**VENTURA UNIFIED SCHOOL DISTRICT
BUENA HIGH SCHOOL STADIUM SURFACING**

BID # E15-25

ADDENDUM #01

Bid Addendum No. A
To the contract documents for BUENA HIGH SCHOOL TRACK AND FIELD REPLACEMENT
For the VENTURA UNIFIED SCHOOL DISTRICT

L2.01

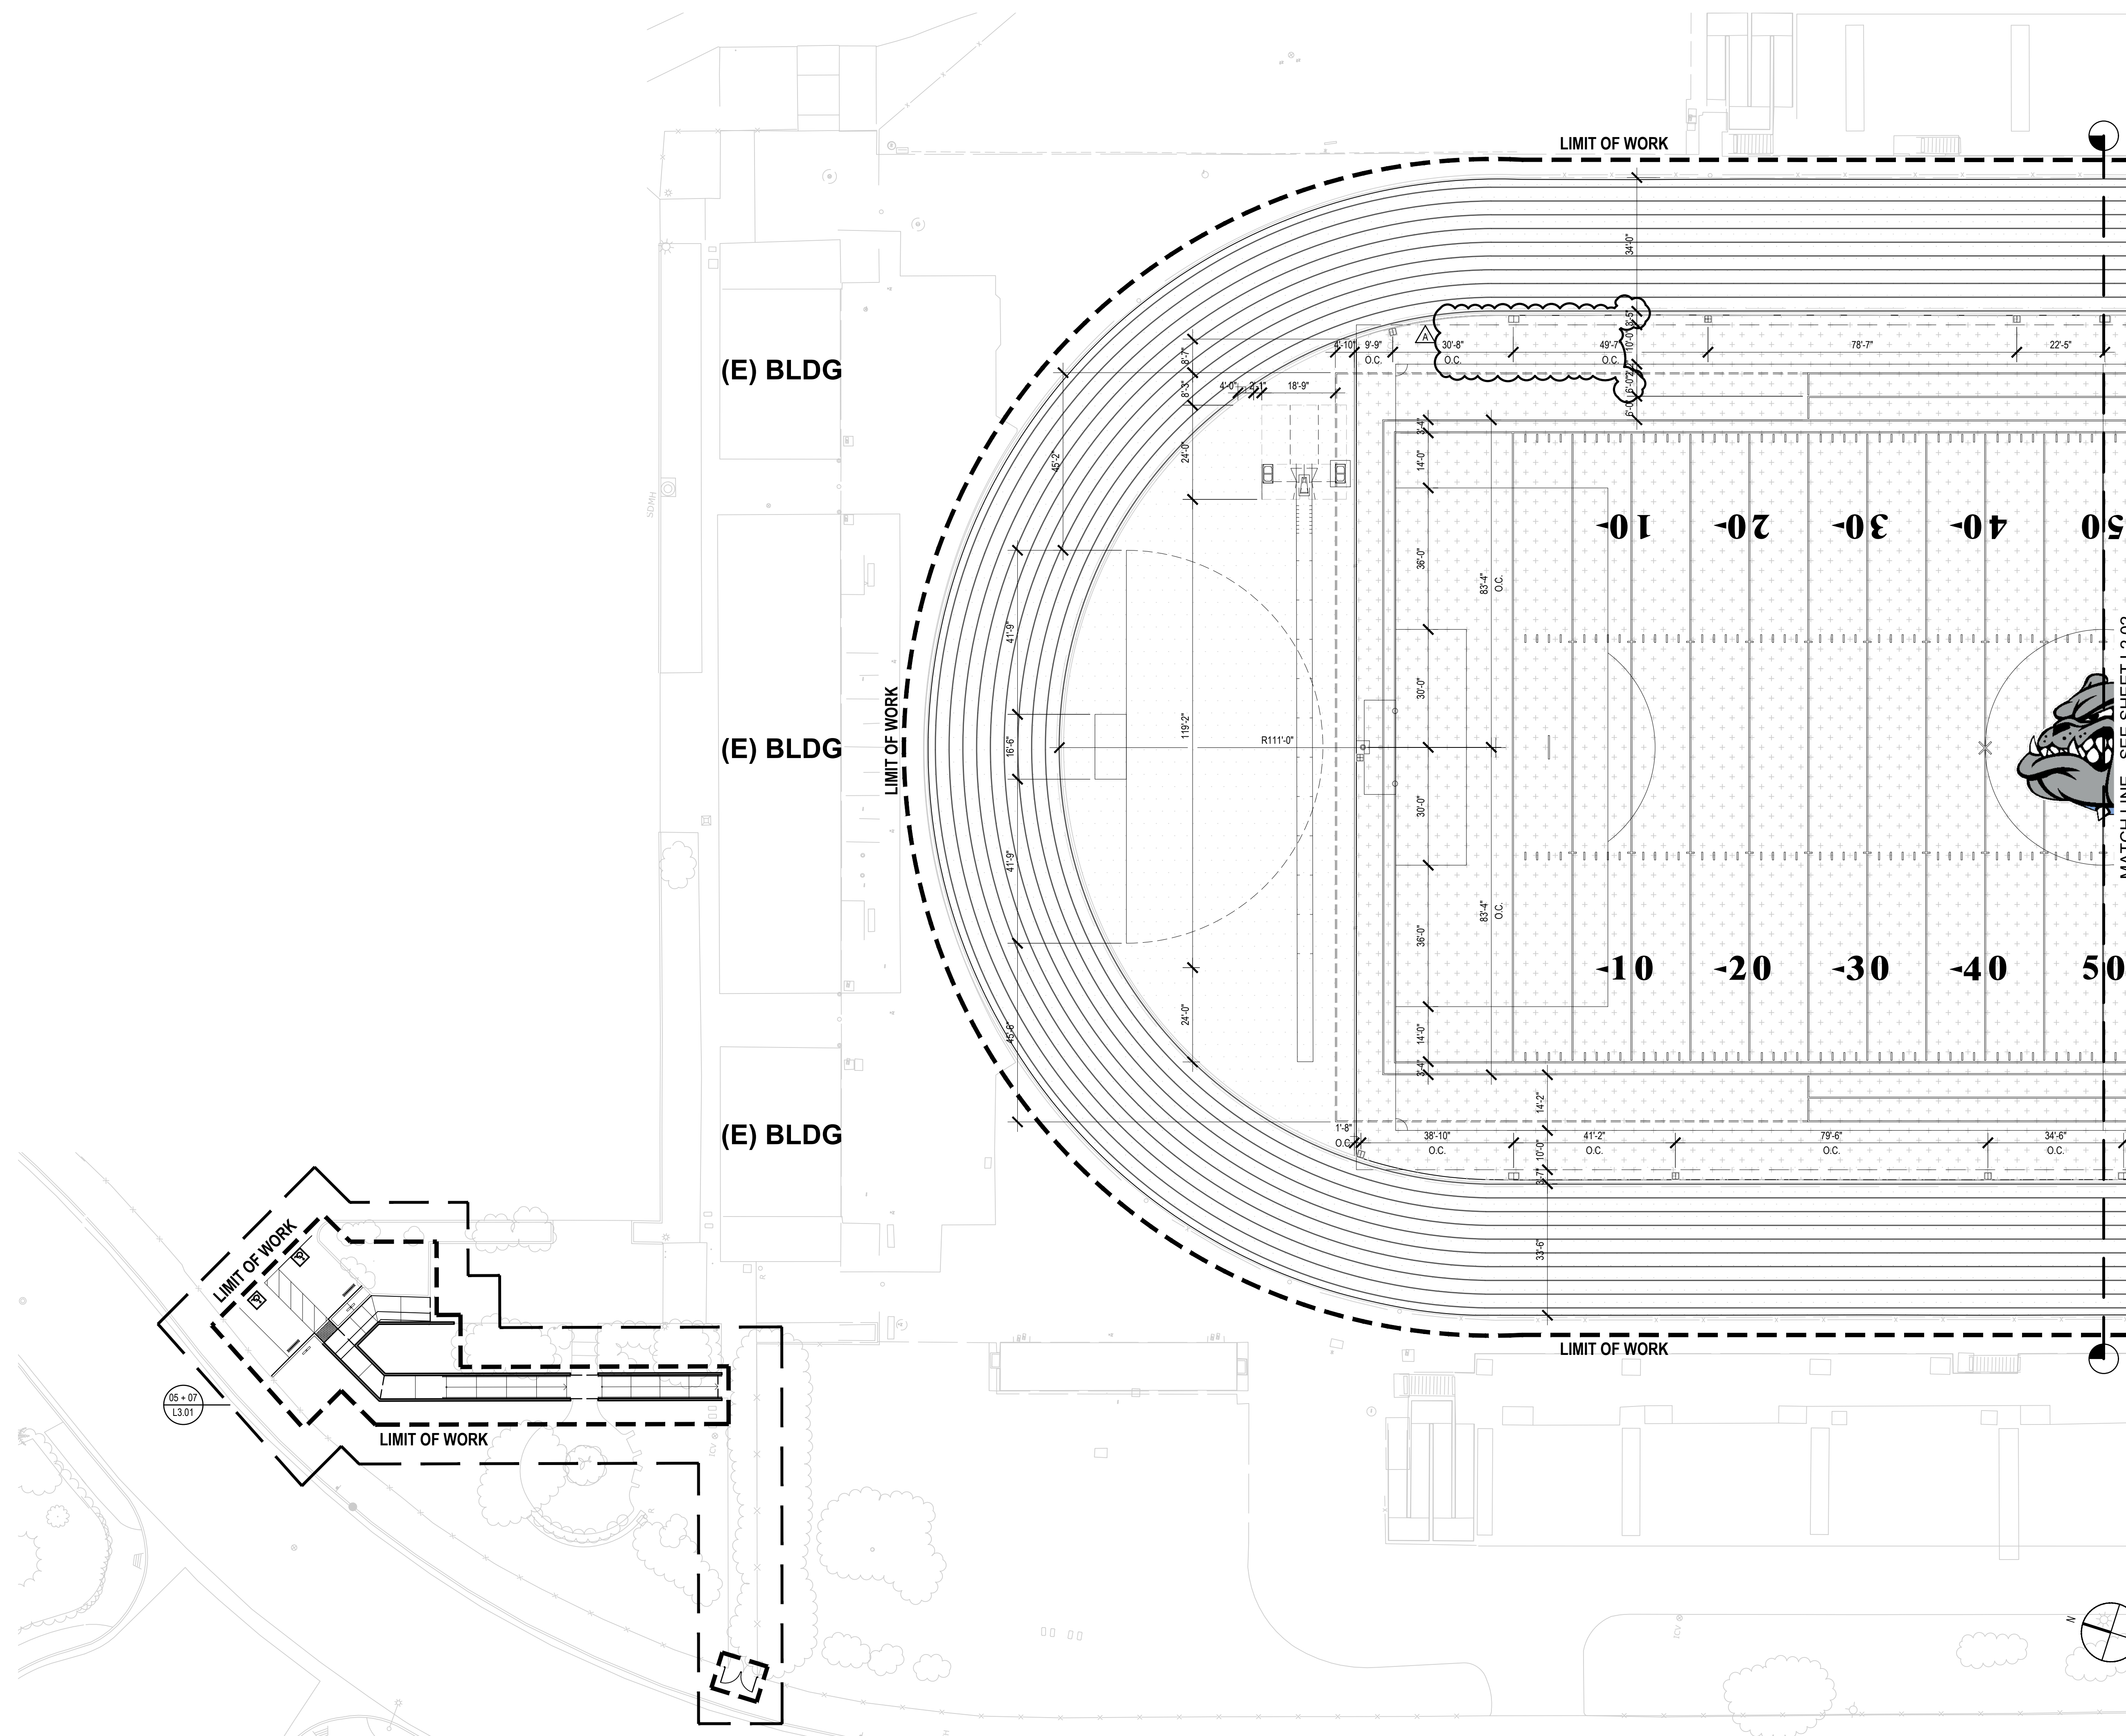
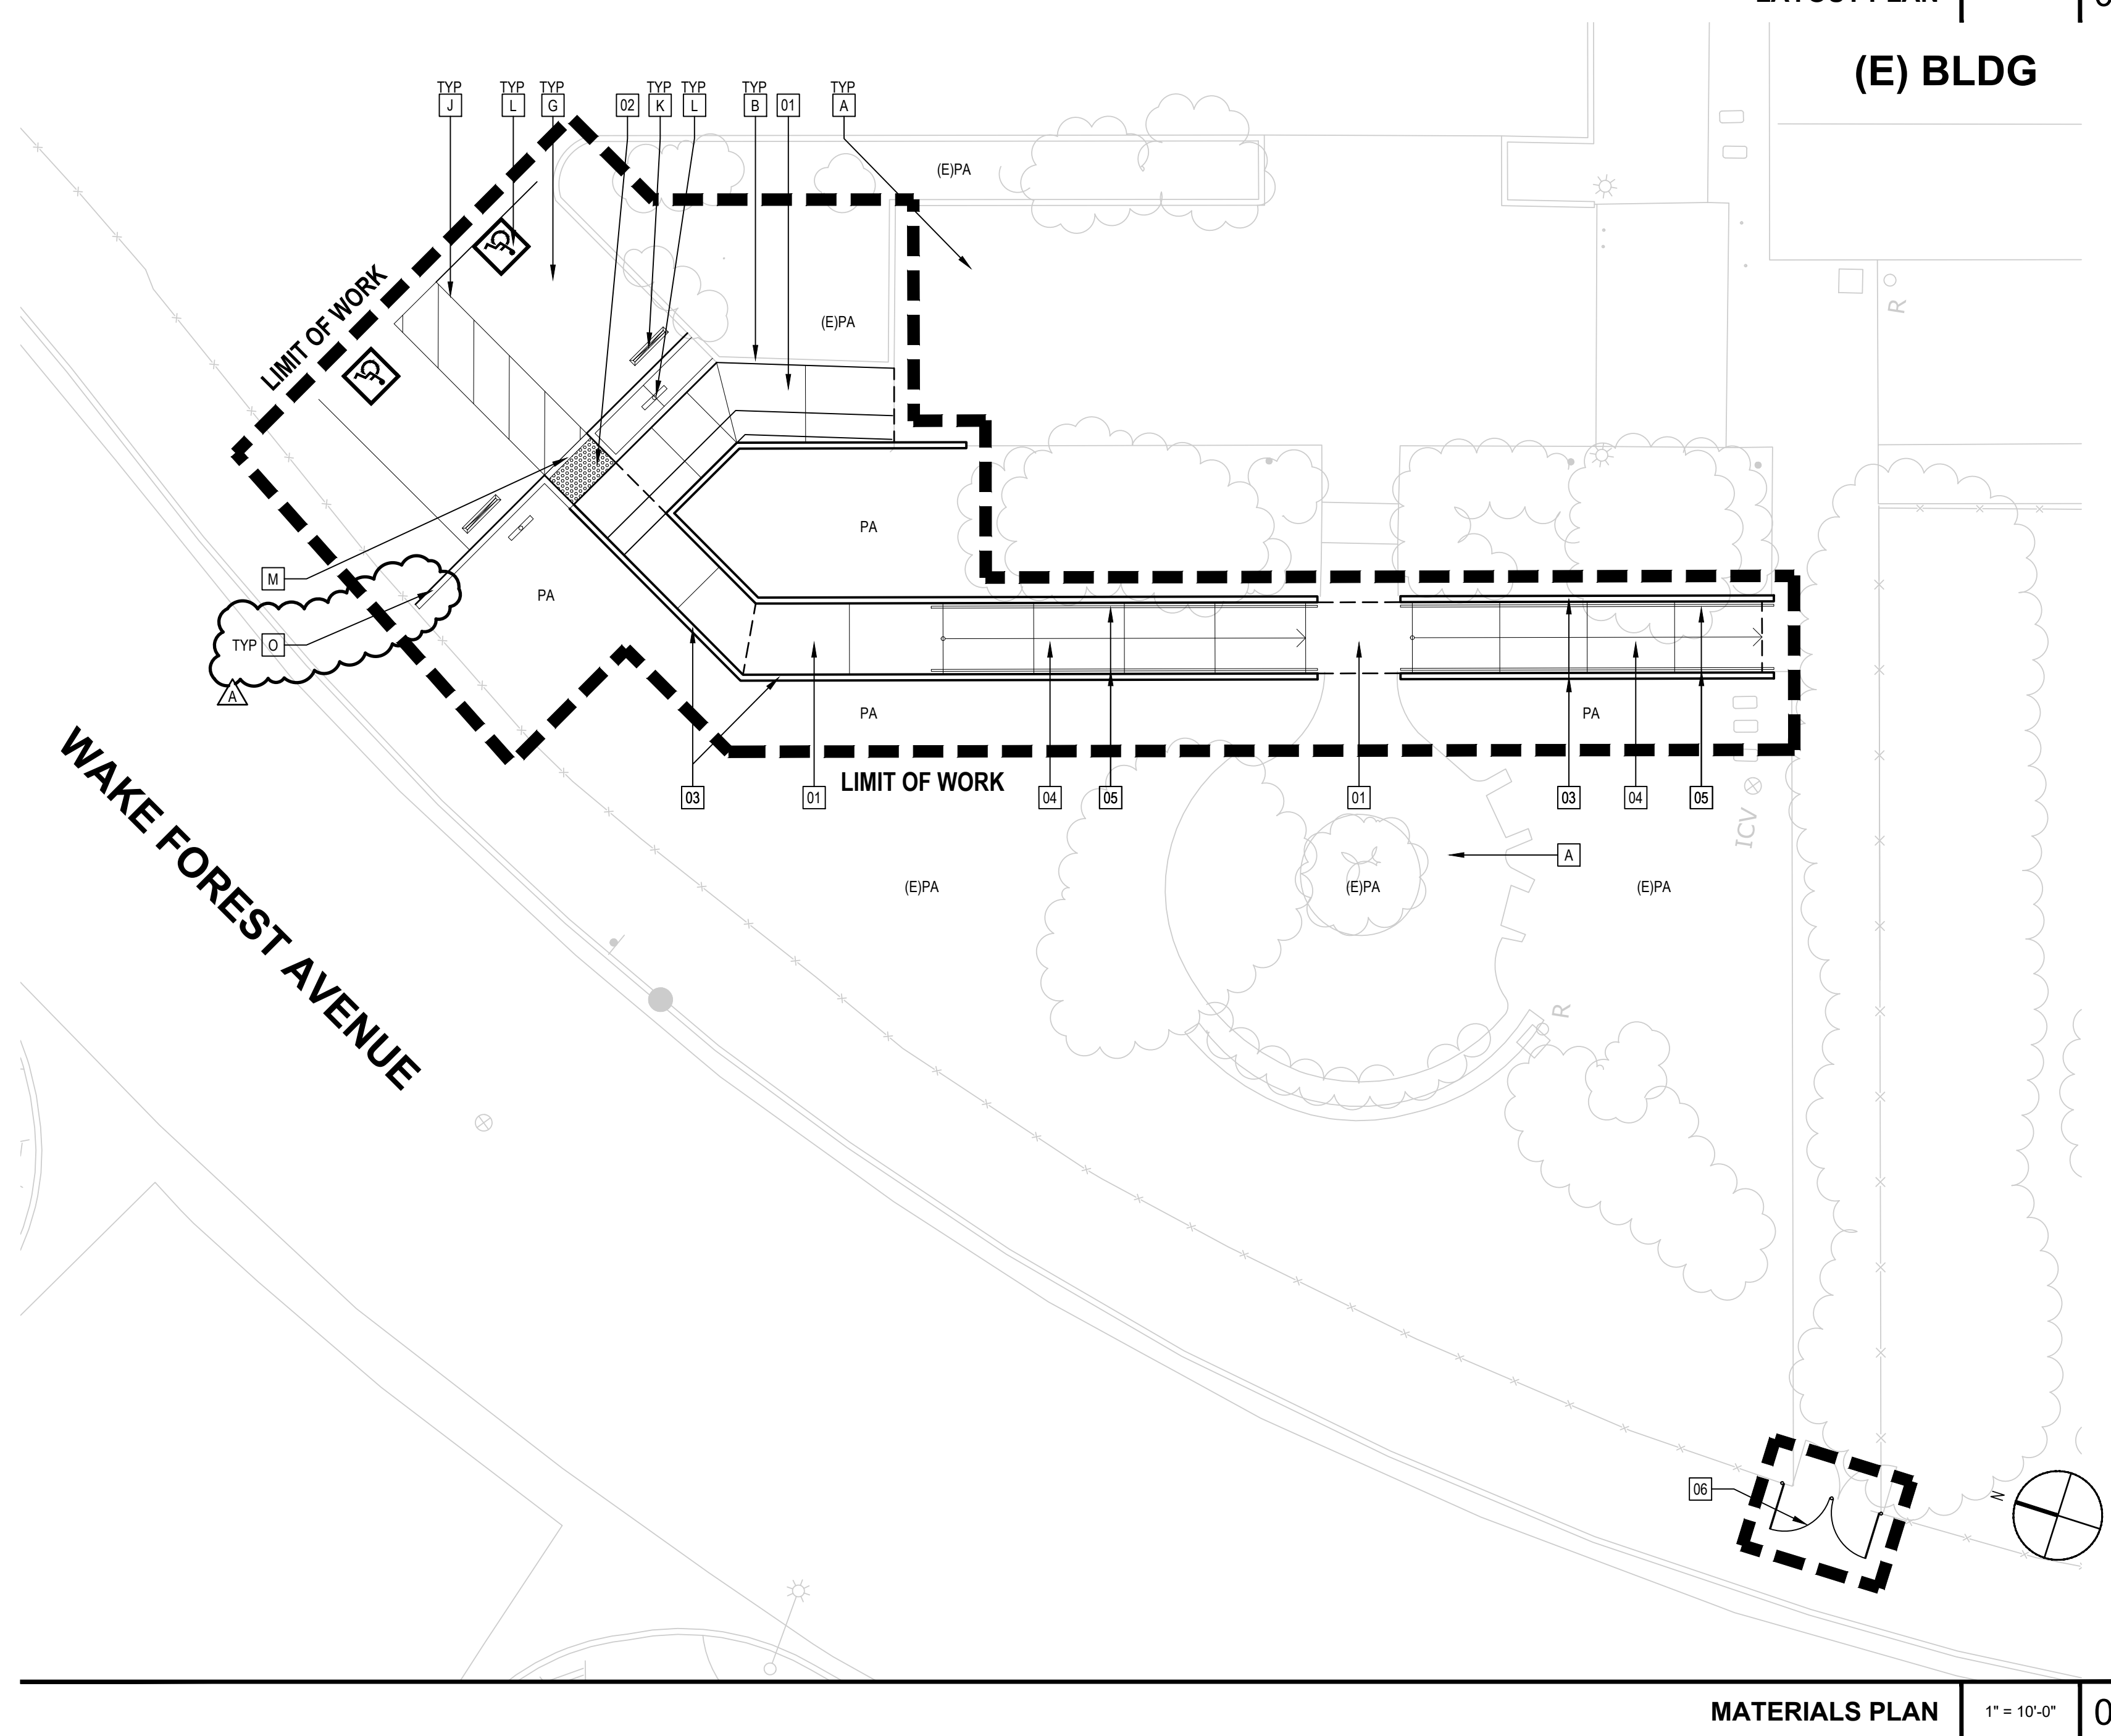
- Item No. 5** **L1.02 MATERIALS PLAN** - Materials Keynote Legend Updated. Keynotes A09 & A10 detail reference updated. Reference keynote O added.
- Item No. 6** **L2.01 LAYOUT PLAN** – Due to added Com box; dimensions updated accordingly.
